Access Compliance Report

Public Rights-of-Way

(Pedestrian Signals)

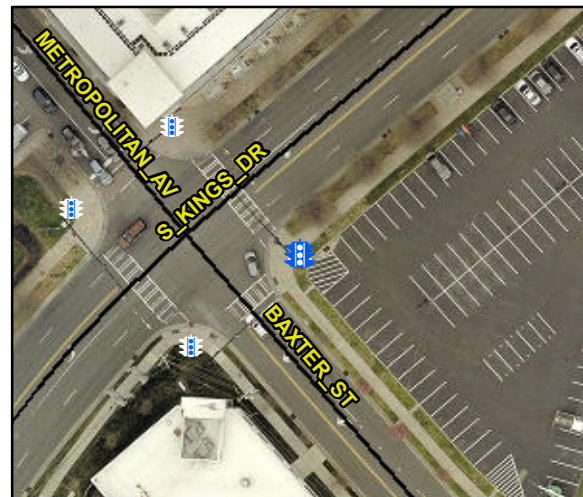
PROW/ADA: TMUTCD 4e.08, R404.2, R404.7.3

Yes	B 1 Clear Xing Direction?	ClearlyMarked	N/A	B 2 Clear Xing Direction?	N/A
	B 1 Crossing Direction	To NW		B 2 Crossing Direction	N/A
Yes	B 1 DistanceTo XWalk (in)	0.0	N/A	B 2 DistanceTo XWalk (in)	N/A
No	B 1 DistanceTo Curb (in)	191.0	N/A	B 2 DistanceTo Curb (in)	N/A
Yes	B 1 Diameter (in)	2.0	N/A	B 2 Diameter (in)	N/A

Possible Solutions: Replace Signal Push Button With APS Button on New Post. Remove & Relocate Sign.
